Subject: Transmittal of revisions to CNWRA Intermediate Milestone 20.01402.461.155—Modeling Magma-Drift Interaction at the Proposed High-level Radioactive Waste Repository at Yucca Mountain, Nevada, USA

Modeling Magma-Drift Interaction at the Proposed High-Level Radioactive Waste Repository at Yucca Mountain, Nevada, USA

Woods et al., Figure 3a

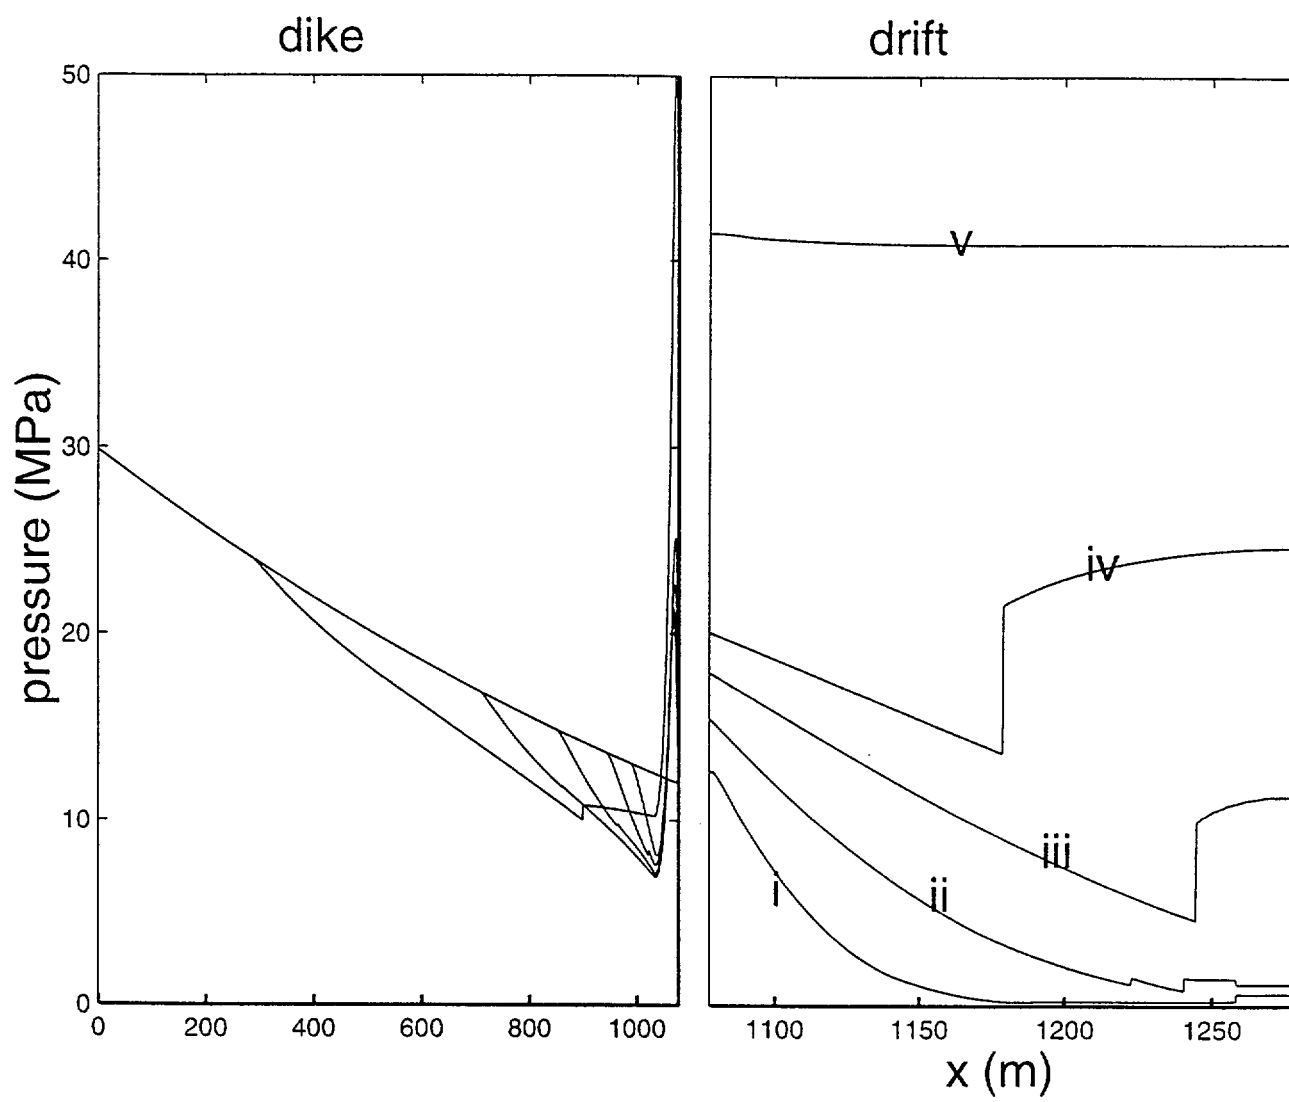
8. Figure 3a-: This figure is confusing. It would be very helpful to somewhere state where the X distance is measured for the dike and for the drift. In addition, different styles of lines for i-v should be used so that the cases can be followed in both the left and right portions of the figures. and

11. Figure 3: As reading left to right in the figure the dike (left) comes before the drift (right), the caption should read "position along the dike and drift" not "position along the drift and dike" The authors agree that figure 3 should be clarified, as few readers have seen the Bokhove and Woods (JGR) paper. This figure will be modified by the appropriate authors.

Woods et al.,
Figure 4

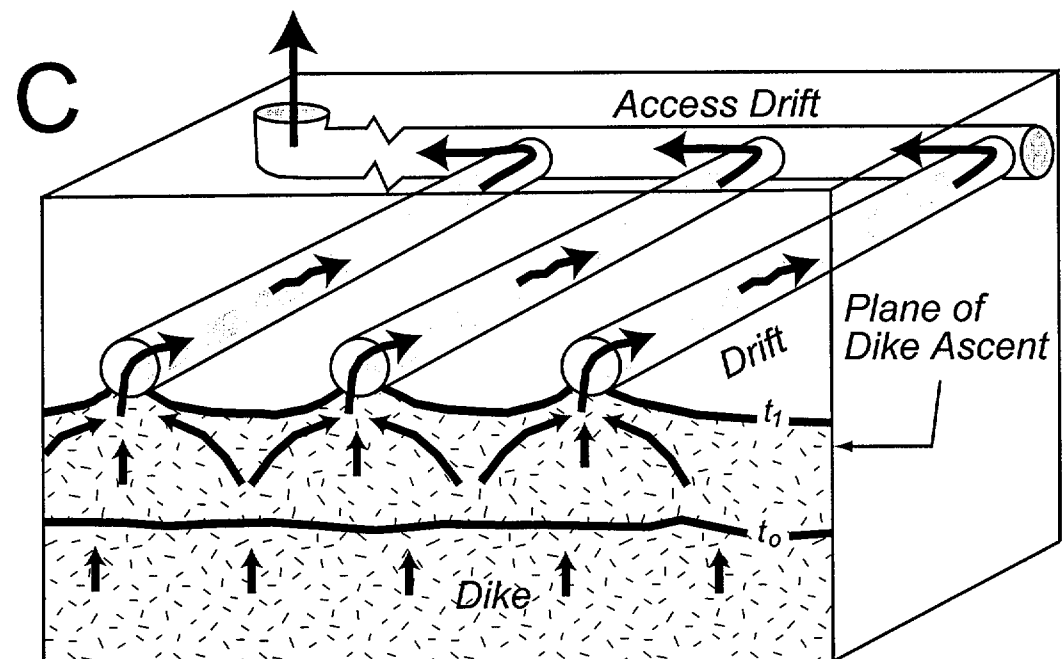
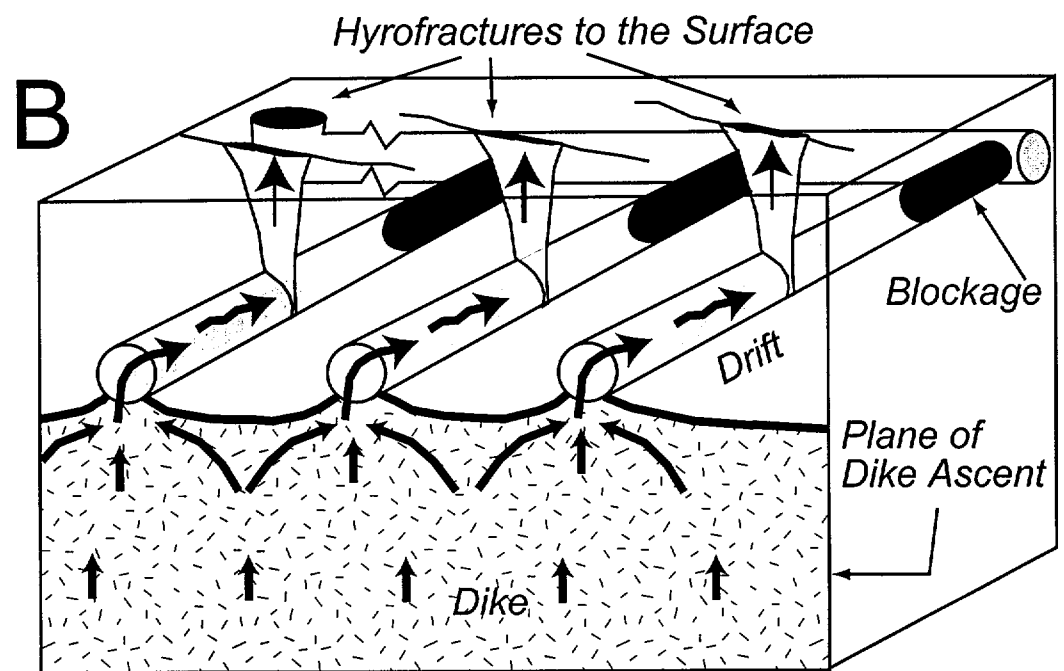
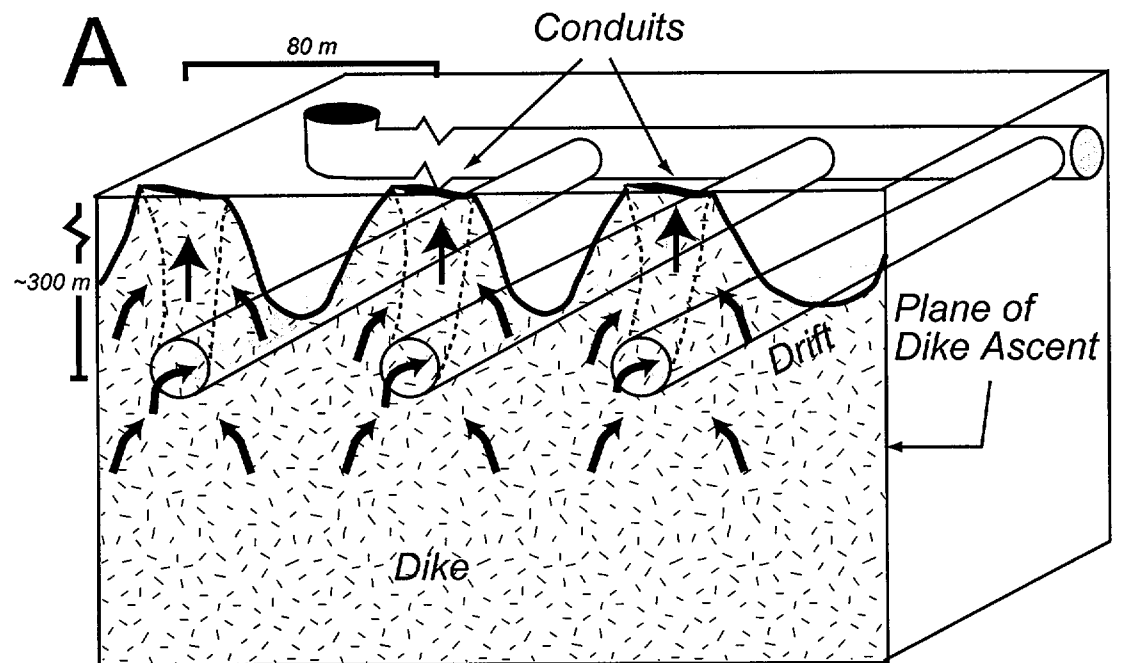
7. Page 4; last paragraph: In describing figure 4a-c, the text clearly identifies the area for Case 2 while the area for Case 1 is not provided and a second sentence apparently provides the area for Case 3. It would help to clarify the areas use and if the assumed area has a significant impact on the pressures observed in the calculations it may require a sentence or two to explain. This is something that would most likely come up in future discussions with DOE.

Agreed, wording changed to "... (figure 4a–c): (Case 1) that the deep dike path continues to the surface without any major perturbation by the repository system, (Case 2) that the pathway to the surface is shifted to a new position, 500 m along a drift with an area of 20 m², and (Case 3) that the magma uses the main access drift to the repository for flow to the surface. This access drift is taken to be 4 km long, with a gentle incline to the surface and a drift area of 50 m². Breakout..."
